December 30, 1985
(NMP2L 0569)

Re: Nine Mile Point Unit 2
Docket No. 50-410

Enclosed is our marked-up copy of the "proof and review" version of the Technical Specifications, which we received from you on November 22, 1985 (Attachment A). This marked-up copy reflects our comments based on our review against the current plant design. Justification for proposed Technical Specification changes is provided in Attachment B, which also contains additional comments and clarifications, and several additional pages which should be incorporated into the Technical Specifications. Attachment C identifies the changes in Amendment 23 of the Final Safety analysis Report which affect the Technical Specifications.

SINGLE LOOP OPERATION
PROPOSED TECHNICAL SPECIFICATION CHANGES

FIGURE 6.2.2-1
NINE MILE POINT NUCLEAR SITE OPERATIONS ORGANIZATION

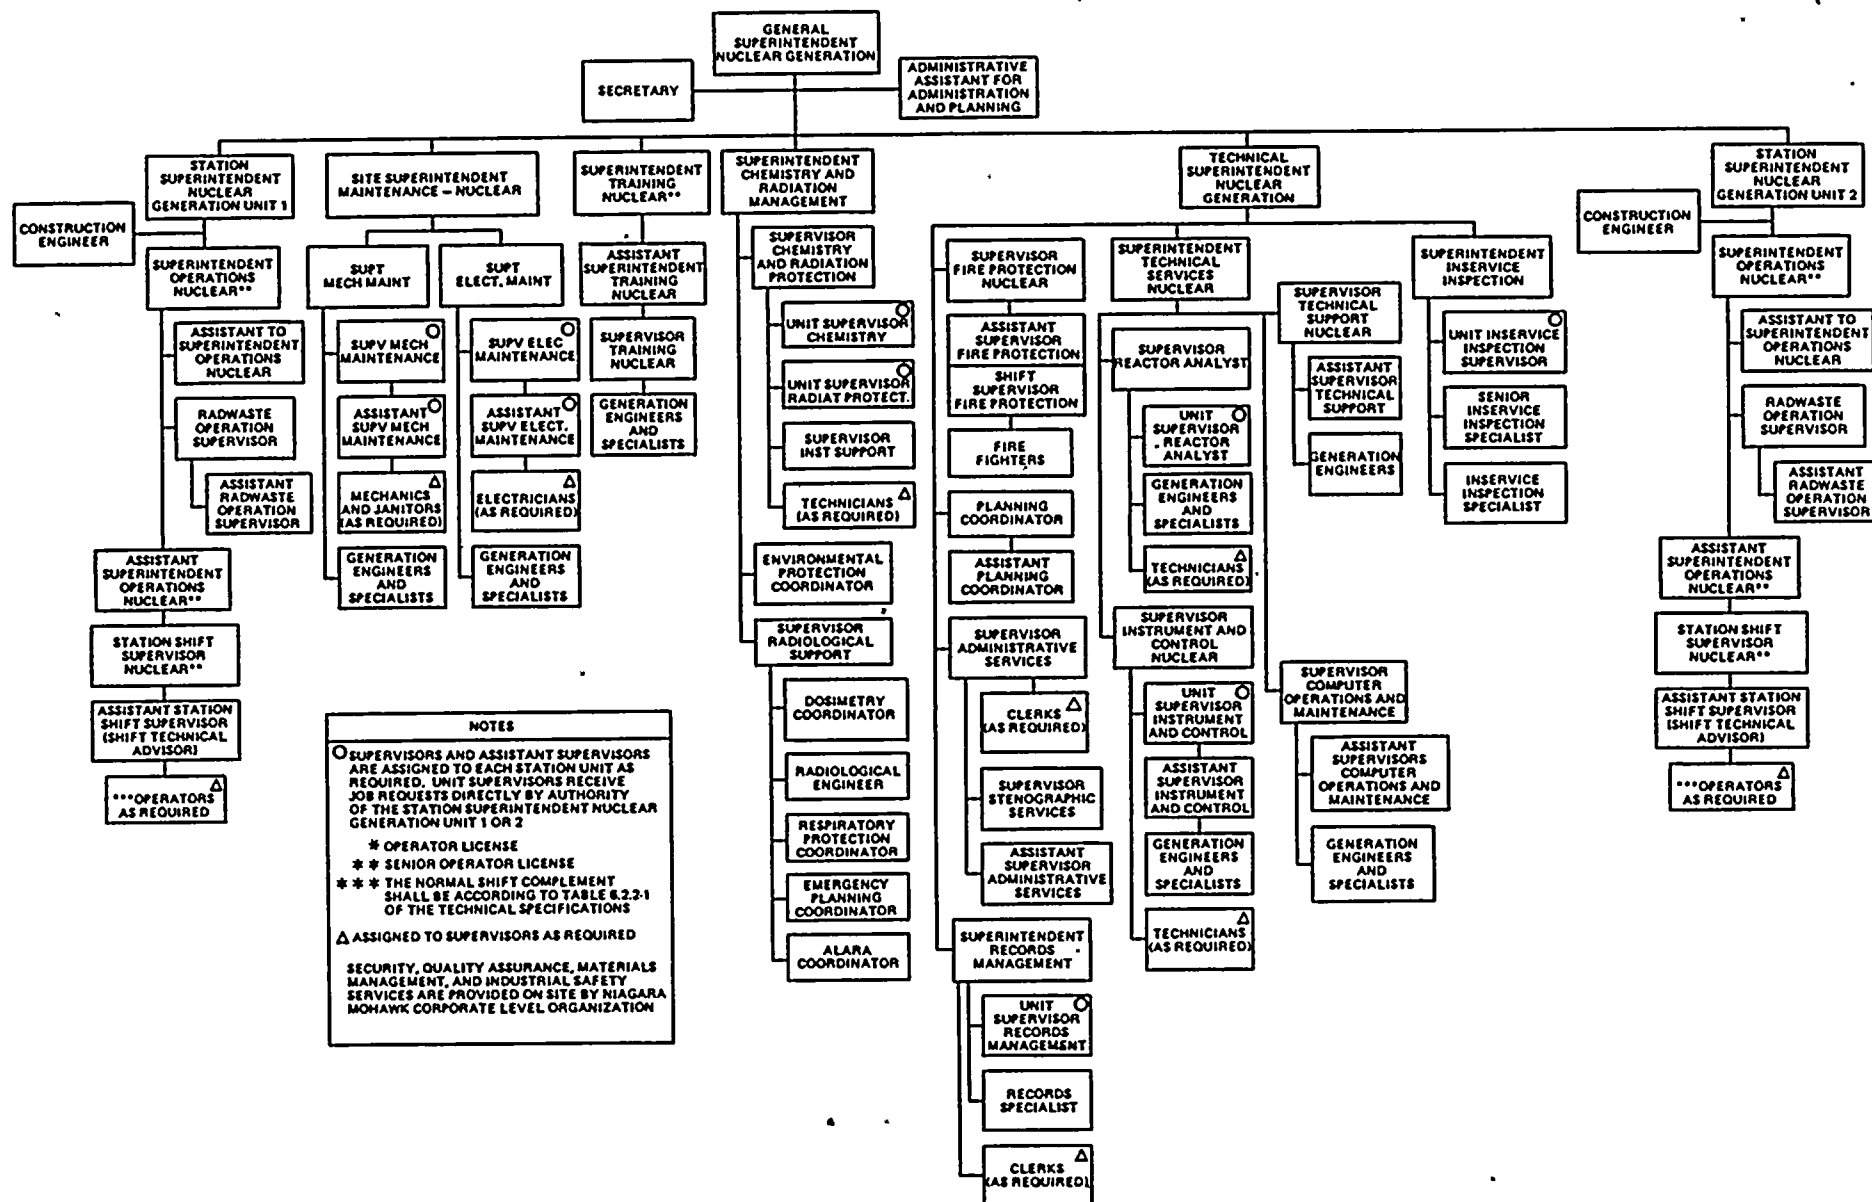
3. Bases page B 3/4 4-6 is provided under Attachment B for inclusion in Tech. Specs.
4. An updated version of Figure 6.2.2-1, 6-4, is provided under Attachment "B" for inclusion in Tech. Specs. The new mylar will be mailed directly to Mr. Schulten.
